Addendum #7

CONSIDER IN YOUR RESPONSE/BID THE FOLLOWING ITEMS OF ADDITION, DELETION OR CLARIFICATION. INDICATE IN THE SPACE PROVIDED ON THE RESPONSE/BID FORM THAT YOU HAVE RECEIVED AND INCLUDED FOR THE REQUIREMENTS OF THIS ADDENDUM. SICKKIDS MAY, IN ITS SOLE DISCRETION ANSWER SIMILAR QUESTIONS FROM VARIOUS RESPONDENTS ONLY ONCE.

RE: QUESTIONS AND ANSWERS, SPECIFICATIONS, DRAWINGS AND DOCUMENTS

**FINISH PLAN,
FURNITURE AND
EQUIPMENT PLAN**

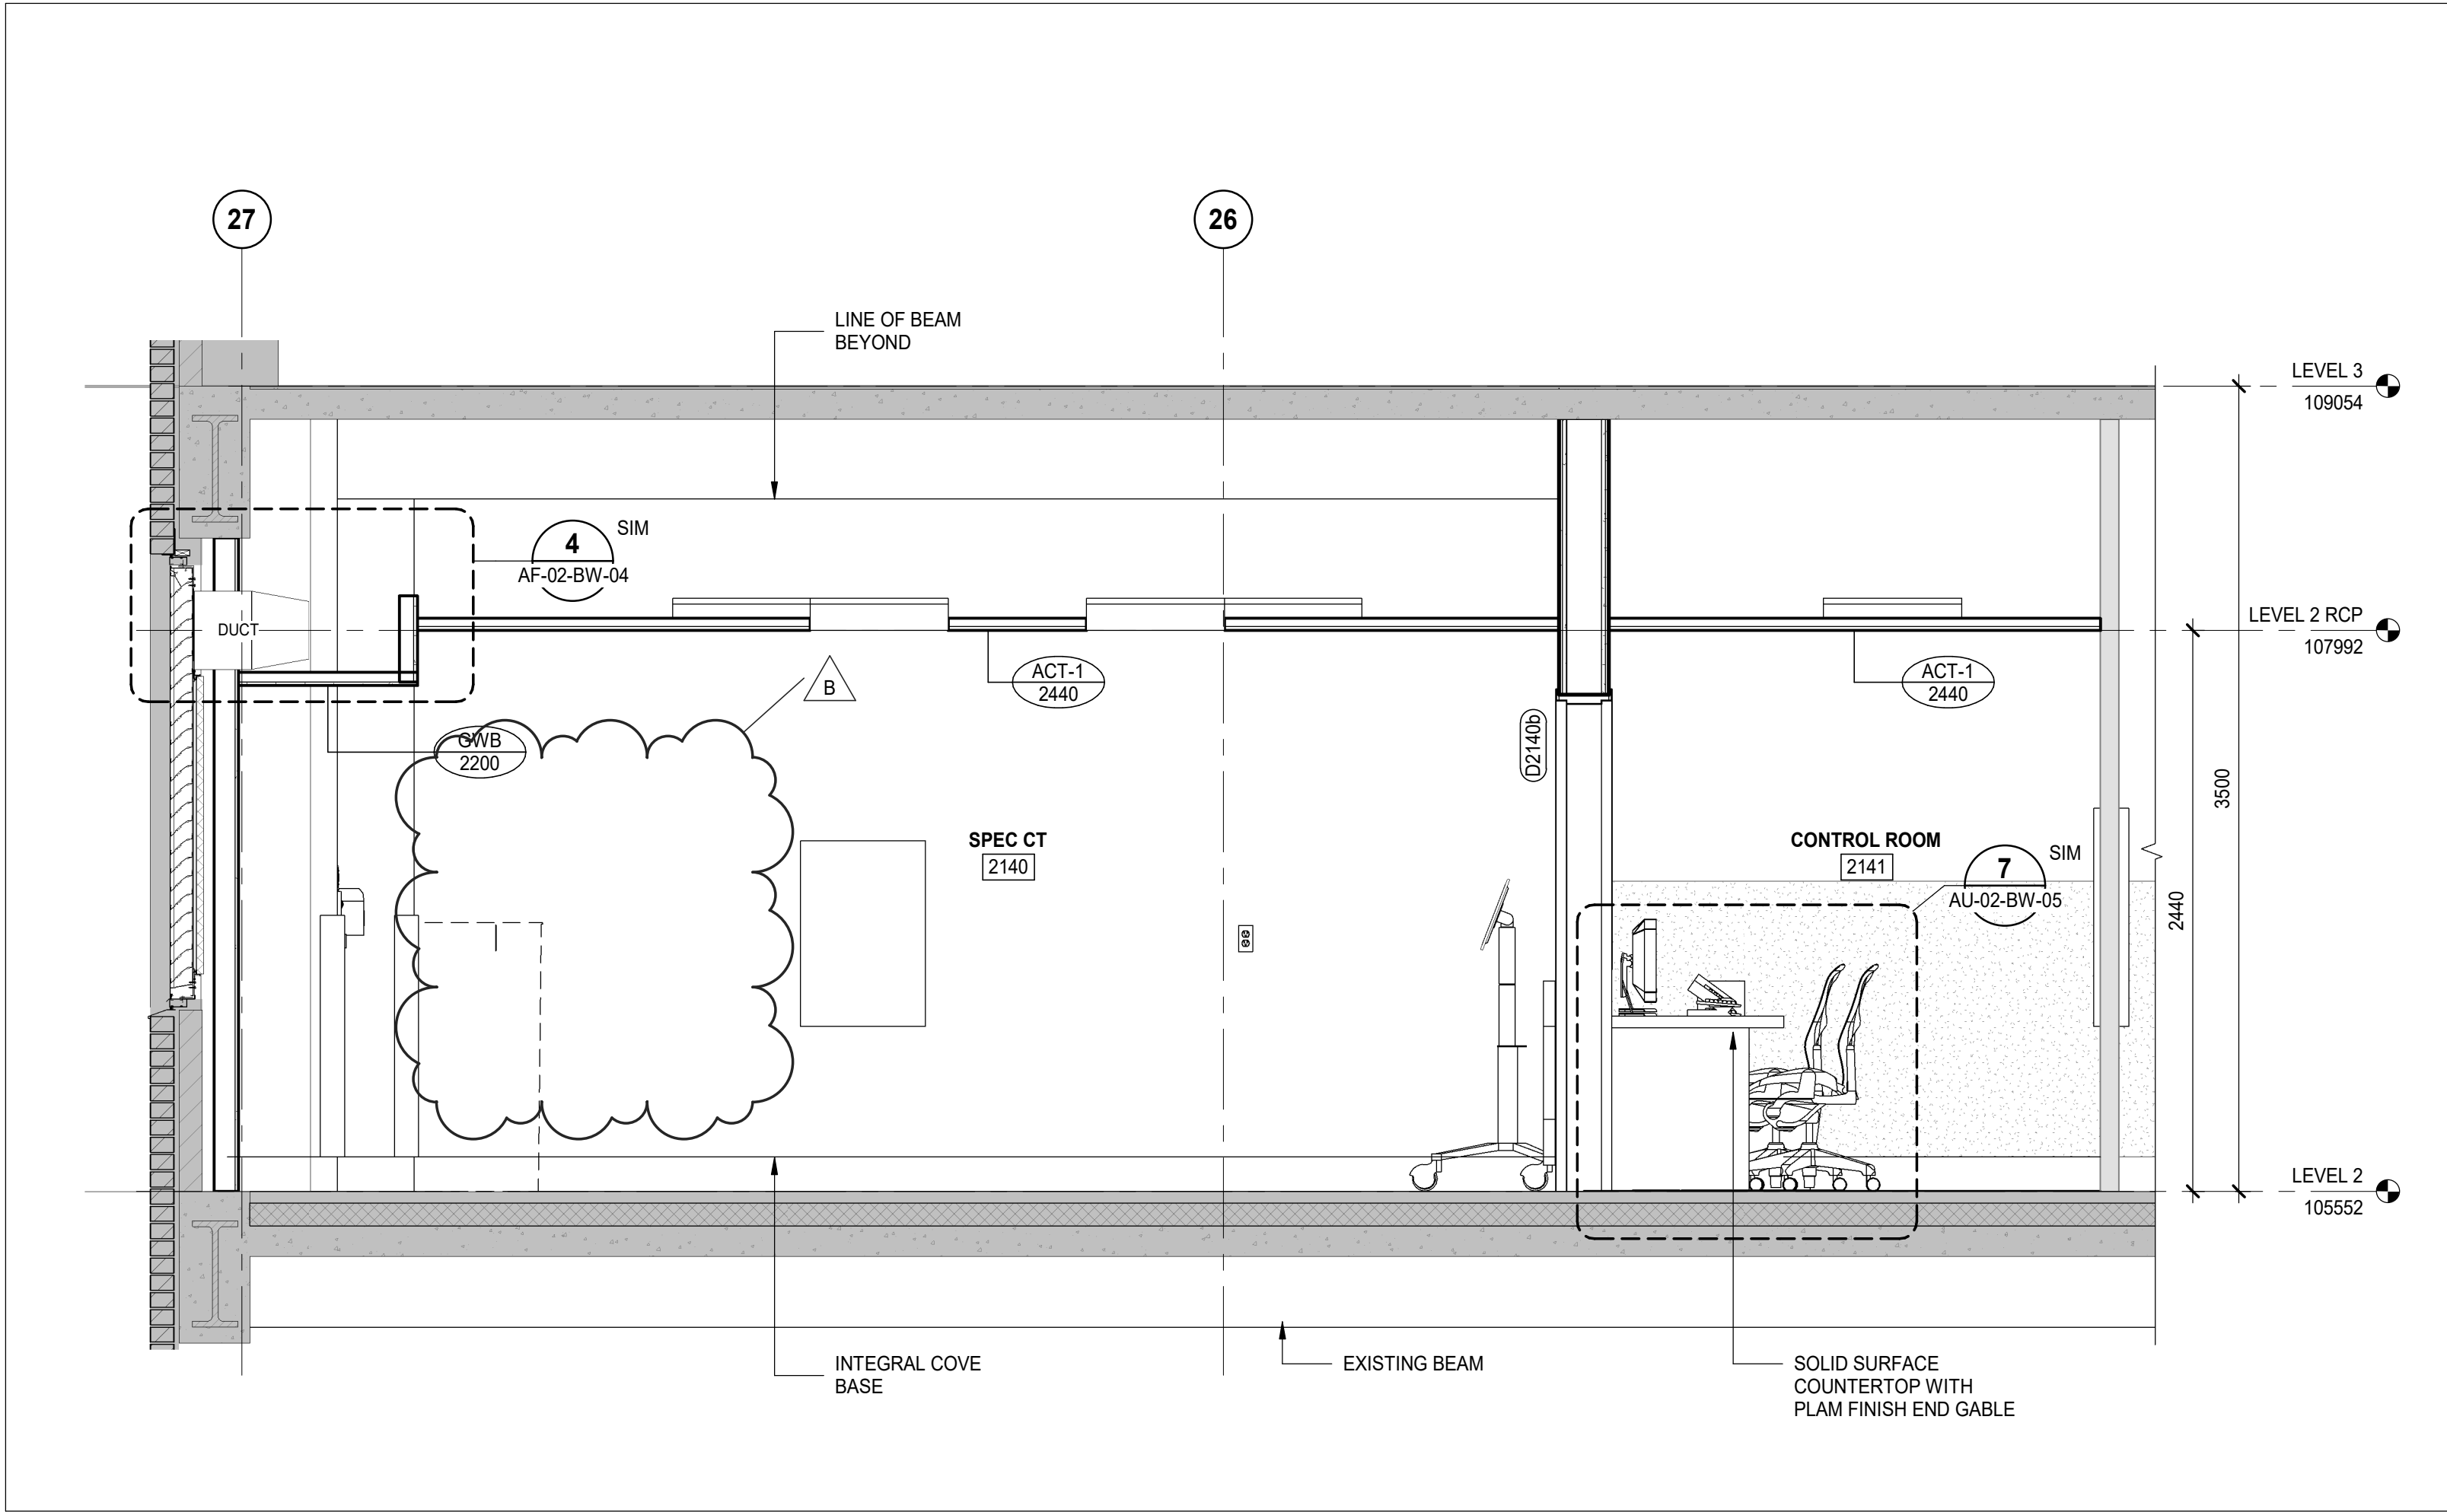
Q70-	How many coat hooks are required?	
	A70-	Please see equipment plan of this addendum for location Two are to be provided.
Q71-	A toilet paper holder (TPH) is specified, but should this be a paper towel holder? There is no toilet on this project.	
	A71-	there is no toilet paper holder. Clarification Paper Towel Holder is provided and installed by SickKids. Contractor to provide backing in location.

- .3 Drawing AB-02-BW-02 FINISH PLAN, FURNITURE AND EQUIPMENT PLAN
Added coat hooks location and med gases valve box
 - .4 Drawing AU-02-BW-01 ENLARGED SECTIONS
Removed Valve Box
